Hampshire Country Club Planned Residential Development

LEAD AGENCY

**VHB Engineering, Surveying, and Landscape
Architecture, P.C.**

RESPONSE TO FEIS COMPLETENESS COMMENTS_JULY 2019

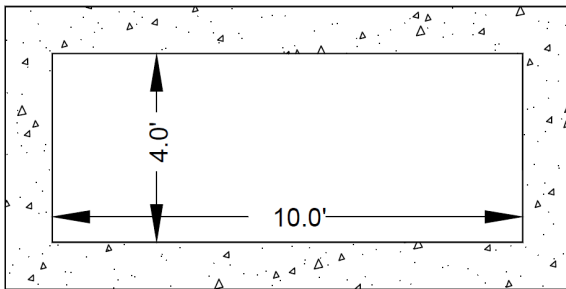
The SWPPP indicates that the drainage channel from the site to Delancey Cove will be modified in order to convey the increased peak flow rate. This channel flows through an existing culvert under Eagle Knolls Road which will remain under the proposed condition. The SWPPP should describe the existing culvert and its capacity to convey the increased runoff, or if improvements to the culvert are required they should be described.

Proposed 100-year flowrate = 222 cfs

Assumed flow velocity = 6 ft/sec

$Q = AV$

$A = Q/v = 222/6 = 37 \text{ ft}^2$

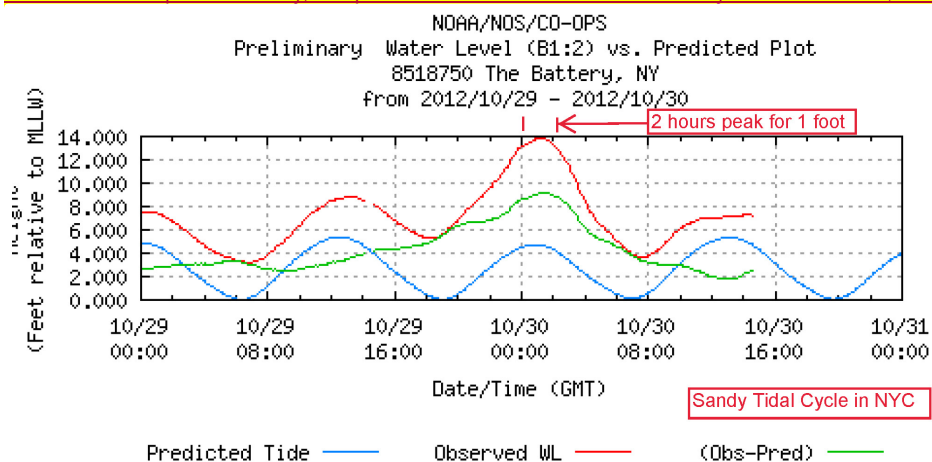
At the request of the Planning Board, the Applicant was asked to also evaluate whether Village of Mamaroneck Fire Department ("Fire") and the Mamaroneck Village Emergency Services ("EMS") emergency access would be impeded on Cooper Avenue during the limited high tide cycle, assuming that the road is blocked by 1' of water.

In 51 years, 2070, sea level rise is estimated by NYSERDA to be an average of 24 inches or 2 feet. In the event that there is a 2 foot sea rise, the 100 year flood elevation will increase to elevation 14 and with that, there will be the possibility that Cooper Avenue could be impeded by a maximum of approximately 1 foot of water during the peak of the high tide cycle (maximum of 2 hours).¹
